ZRD2: Zoning Challenge with response

Job No. 121187964 -1299 3 Avenue, MH -- Plan Exam -- Approved 02/22/2021; ZD1 approved 02/22/2021
Zoning Lot located partially in C1-9 and R8B Districts.

RE: Zoning Challenge
1299 Third Avenue
Block 1429, Lot 4
Job No: 121187964

Axonometric view of 1299 Third Avenue, color coded using traditional land use colors and other buildings to stay on the same zoning lot

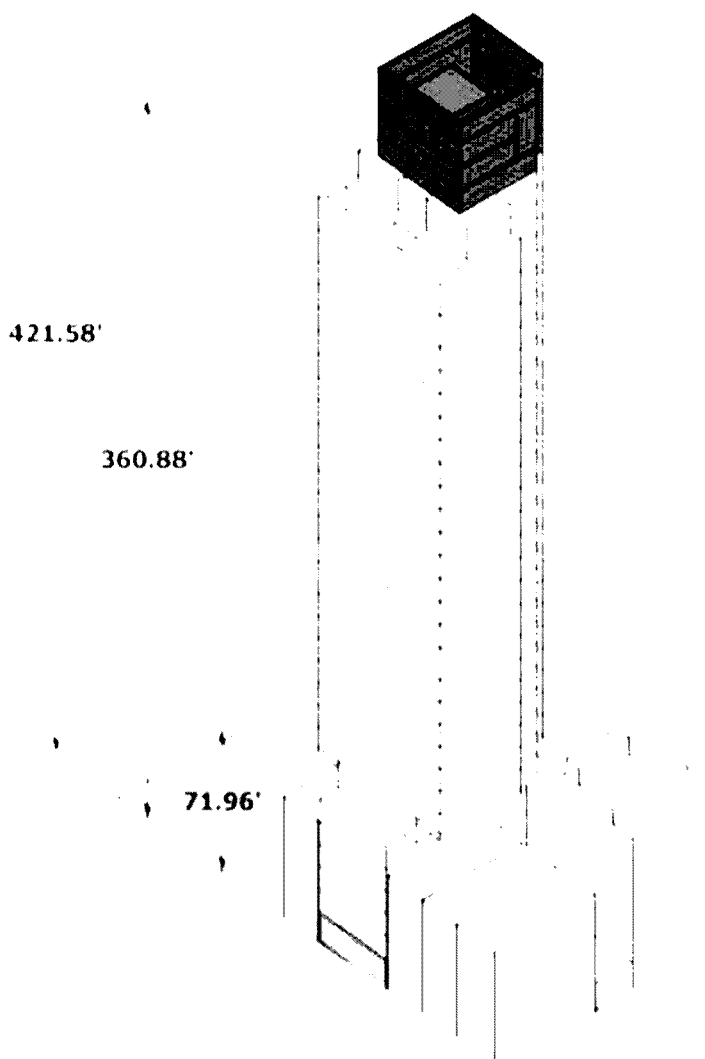
1) The tower-on-base calculations (tower coverage/bulk packing) are incorrect leading to non-compliances.

There are two problems with the applicant's tower-on-base calculations:

Detail of North-South and East/West Sections from Z-006. The seventh floor is highlighted.

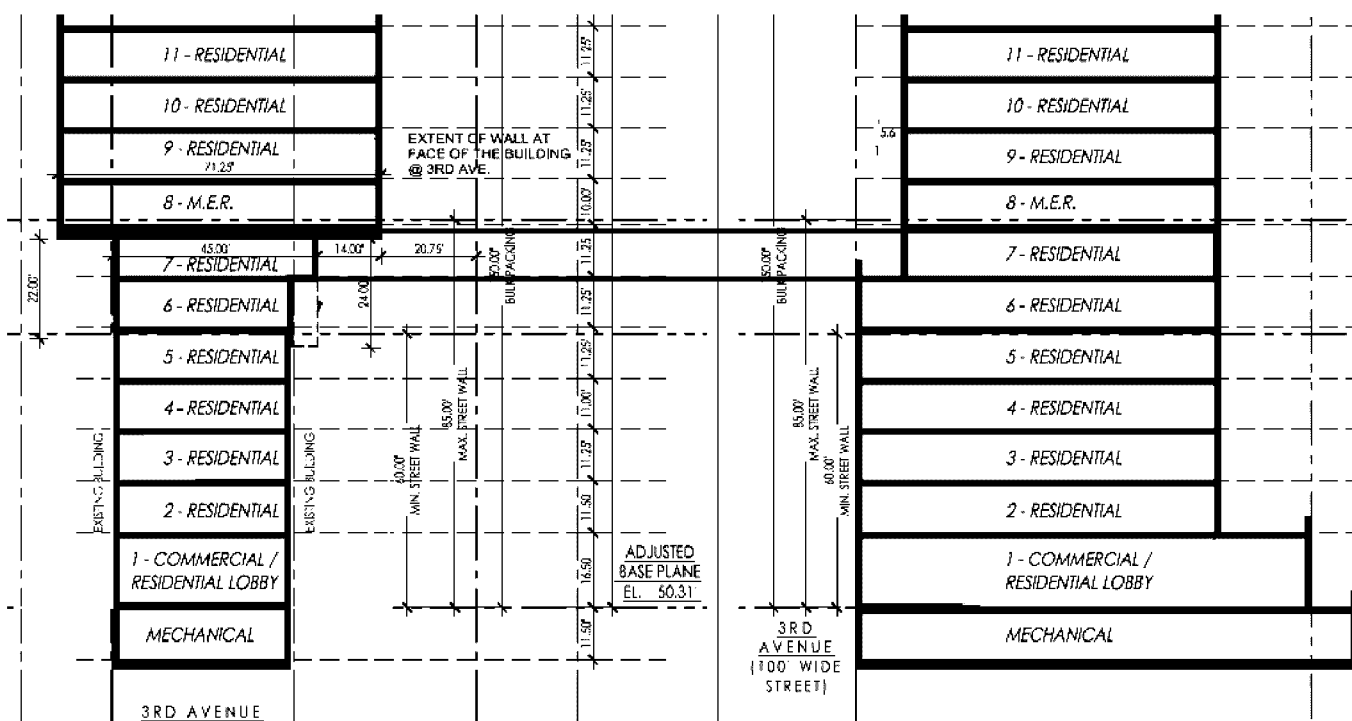
1.a The Challenger states that the 7th floor cannot be considered part of the building base as it's street wall is set back 10' from the street along its entire length which exceeds the maximum of 8' for at least 30% pursuant to ZR 23-651(b)(1)(i). Further, that 7th floor does not comply as part of the tower in that the total tower coverage of such floor does not meet the minimum of 30% pursuant to ZR 23-652.

All of the seventh floor of the proposed building is setback 10 feet from the street line, so it does not qualify as being part of the base. The base rises up from the streetline to the sixth floor and entirely sets back at the seventh floor. The seventh floor, therefore, is a tower floor, as defined by 23-651.

Tower-on-a-base requires that tower floors have a minimum tower coverage of 30% (23-652). The C1-9 portion of the lot is 12,270 SF. Thirty percent of that is 3,681 SF, but the 7th floor is 3,118 SF, or just 25.4%. This tower floor is too small and does not comply with the requirements of a tower floor that is not located at the top of the building.

Response: 1.a) A review of the application records indicates that, at the time of the above referenced ZD1 posting, the challenger's findings are correct that the 7th floor as proposed does not comply with ZR 23-651(b)(1)(i) nor ZR 23-652.

It should be noted, at the time of this response, post approval amendment (Document 3) was filed by the applicant and approved which indicates the 7th floor street wall at 8' from the street line in compliance with ZR 23-651(b)(1)(i). A new ZD1 has been posted.

Detail of the ZD1 Plan showing the roof height facing 75th Street and the base plane from the ZD1 Section

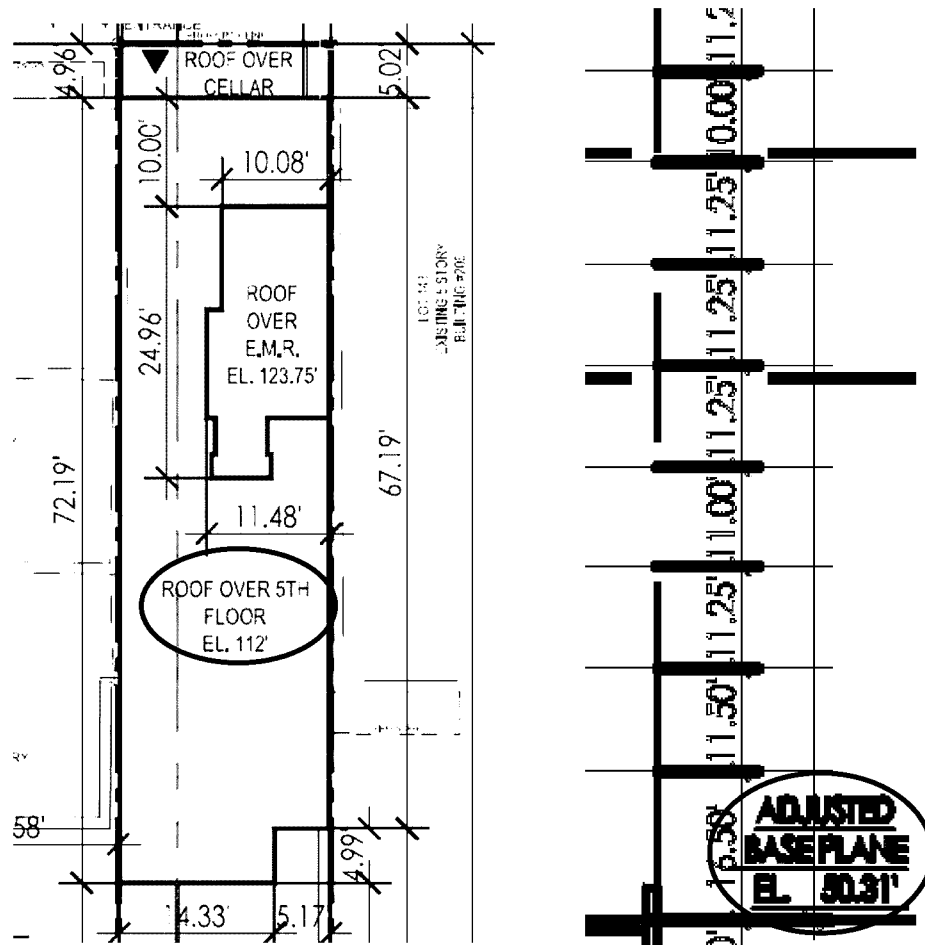
The Challenger states that the portion of the building facing 75 Street is 61.69' in height measured to the indicated base plane in excess of the maximum 60' height pursuant to ZR 23-692.

The new building that faces 75th Street is shown in the ZD1 at elevation 112 feet. The adjusted base plane for this building is at elevation 50.31 feet. The following details from the ZD1 show these data:

If the elevation of this building is 112 feet, and the base plane is 50.31 feet, subtraction tells us that this building is 61.69 feet tall. ZR 23-692 limits residential buildings less than 45 feet wide to the height of adjacent buildings or the width of the street it faces. The street (75th Street) is 60 feet wide and the neighboring buildings are each less than 60 feet tall, which means a building at this location is limited to 60 feet in height. Yet the building is proposed at 61.69 feet. The approval should be revoked.

Response 2: A review of the application records indicates that, at the time of the above referenced ZD1 posting, the challenger's findings are correct that the proposed height of the 5 story portion of the building and it's street wall exceeded the maximum 60' pursuant to ZR 23-692.

It should be noted, at the time of this response, post approval amendment (Document 3) was filed by the applicant and approved which indicates the height of such portion of the building is 59.98'. A new ZD1 has been posted.

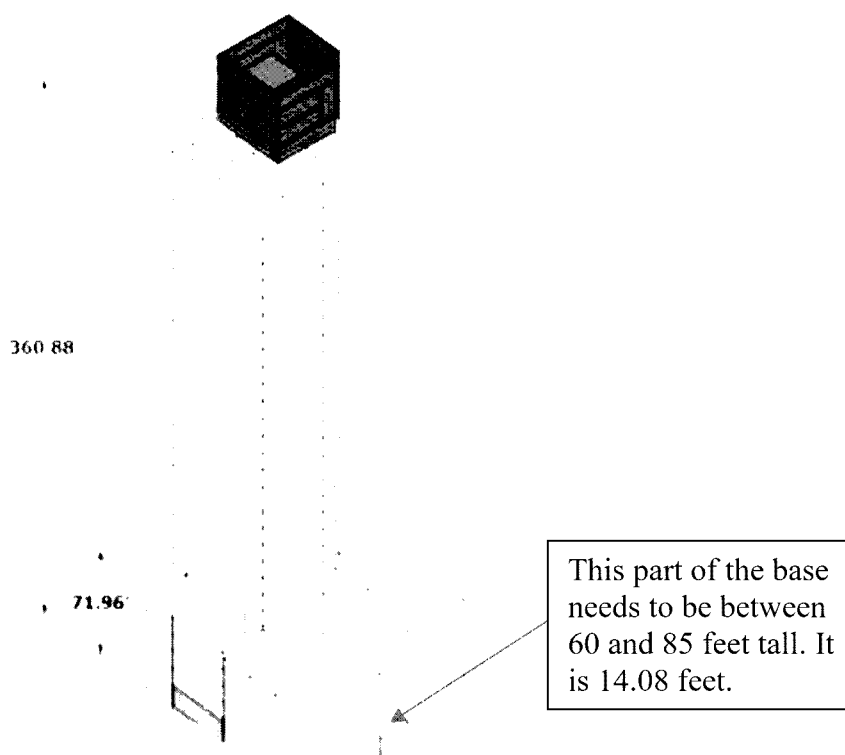
The Challenger states that the portion of the building facing 74 Street is only 14' in height and does not comply with the Tower-on-a-Base provisions of ZR 23-651.

The 17.85 foot wide base that fronts 74th Street is 14.08 feet tall and 100 percent of the aggregate width exceeds a depth of eight feet. The following axonometric image illustrates where there is a problem with the base:

The purpose of the tower-on-a-base regulations is to create a continuous streetwall in a base that is of similar size as historic five-story tenements. The proposed building base is not only contrary to the letter of the law, but also the spirit of it. The approval should be revoked.

Response 3: A review of the application records indicates that the area referenced by the challenger is not part of the building/development in question. Rather, these are each a one story horizontal enlargement filed on the existing buildings on lot 1 – 1291 3rd Avenue and lot 2 – 1295 3 Avenue. These were filed under application numbers 121188339 and 121188320 respectively. All three application records indicate lawful convenience access doors between the three buildings with no required egress function. Neither of the two enlarged buildings include a tower and as such are not subject to ZR 23-651.

Reproduction of A-103, which is one of many pages showing the non-compliant one-story portion facing 74th Street as part of the same building as the tower

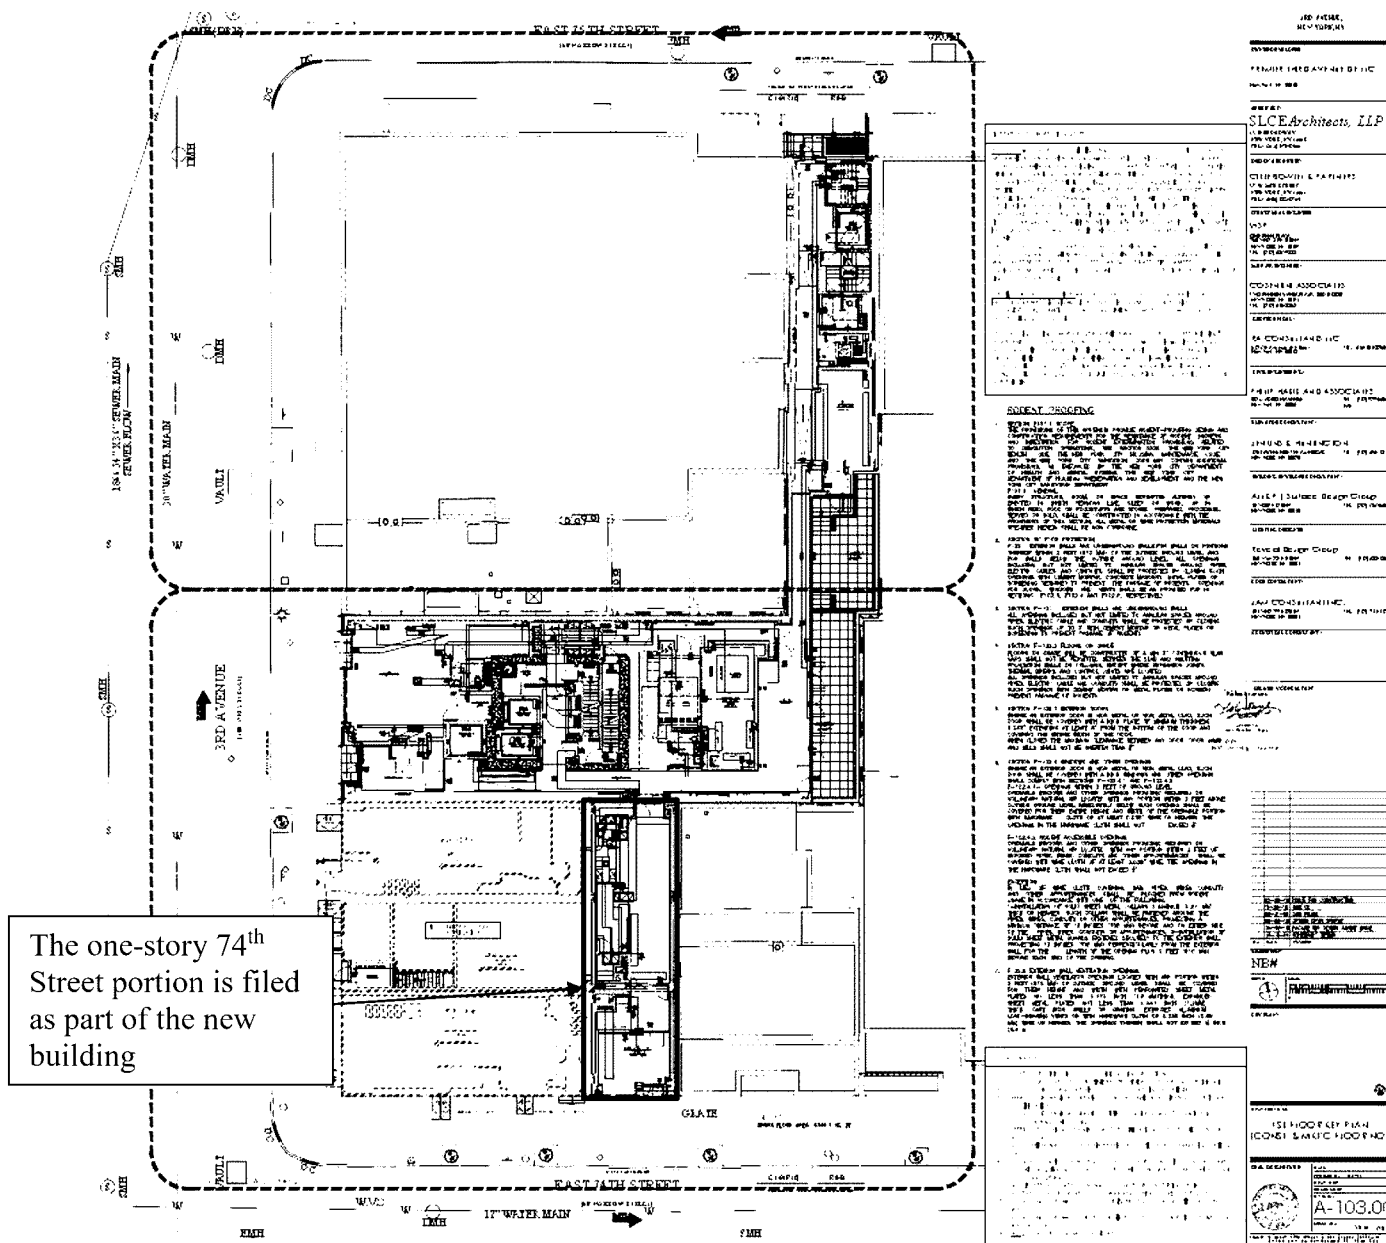
The one-story 74th Street portion is missing from the zoning series, however. The filing for this building describes one building in the Z-series and another in the A-series. This is an error. The building described in the A-series must show how it complies with zoning in the Z-series. Buildings cannot be segmented into pieces each with their own approval because it cannot comply when evaluated as a whole. Building plans must be internally consistent and describe the same building, yet these stamped approval plans do not.

Since this one-story portion is on the same zoning lot as the tower and ZR 23-651 requires that the regulations apply to “any #development# or #enlargement#,” on the zoning lot, and since these additions are not built or permitted, the Department’s approval is in error. ZR 23-651 requires a base of at least 60 feet here and the plans the Department have stamped and approved should be internally consistent.

A plan view of floors 17 through 23 with walls facing Third Avenue, color coded by width (top) and a legend for the color and the amount of green wall deduction taken by this one wall segment (bottom left). A detail of the French door wall on the right. Most of this wall is open air.

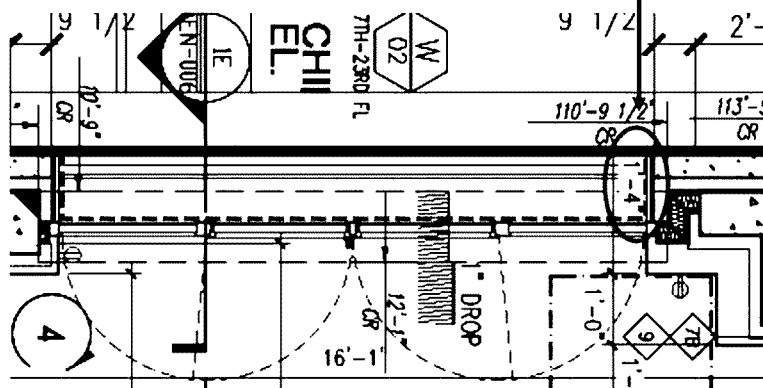
The purple portions of the wall are thick and easily qualify. The red portions of the wall are 13.75 feet, which means 5.75 inches can be deducted. The green portions of the wall are 9.1 inches, which means 1.1 inches can be deducted. The blue portions of the wall note a floor-to-ceiling French door which is just 3.4 inches wide. Since it is less than 8 inches, none of it can be deducted.

The applicant is claiming 46.56 SF deduction for this one wall for this one floor, taking the full eight inches, even though most of this wall does not qualify for the full deduction. When the math is done on the wall thickness calculated by segment, just 18.21 SF can be deducted, a 61% reduction in the floor area exempted. If other floors are similarly overstated, this building is easily out of compliance with the maximum floor area for the lot, considering the thousands of square feet taken in green wall deduction.
